OUTDOOR POWER EQUIPMENT
INSTITUTE

June 15, 2011

This letter, submitted on behalf of the OPEI/ANSI B71.9 Committee (the “Committee”), addresses CPSC Staff’s comments to the second canvass draft of ANSI/OPEI B71.9-20XX, *American National Standard for Multipurpose Off-Highway Utility Vehicles* (the “MOHUV Standard”). Your letter raises four issues: the acceptance criteria for the J-Turn test; the desire for a steering gradient test with criterion; the absence of a passenger car type seat belt warning requirement; and the lack of testing procedures and performance requirements for side retention devices. Each of these items is addressed below.

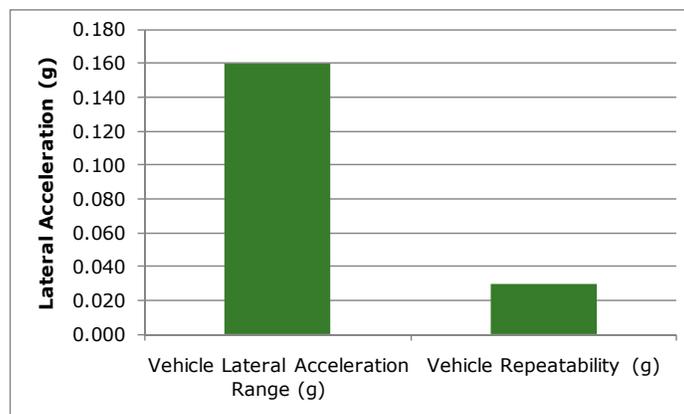
One of the issues the Committee considered was whether the acceptance criteria should include lateral acceleration in addition to two wheel lift. The primary advantage of two wheel

lift as the acceptance criteria is that it can be verified visually and is repeatable. The problem with including a single lateral acceleration value is the likelihood of inconsistent results, even when the tests are run with the same vehicle.

The variability associated with lateral acceleration data has three main components: vehicle response, instrumentation, and driver input. Variability in vehicle response is caused by tire to ground interaction and damper response. Instrumentation inconsistency can be caused by dynamic input, whether it is GPS or accelerometer based, and the location of the instrumentation on the vehicle. The speed and steering input required to attain a specific lateral acceleration response may vary from driver to driver and from test to test. An additional complicating factor is that there are different techniques for post processing of the collected data which could result in additional variation in reported numbers. These potential problems would make it difficult to designate a single lateral acceleration value that would correspond with two wheel lift over many different vehicles and many different test setups.³
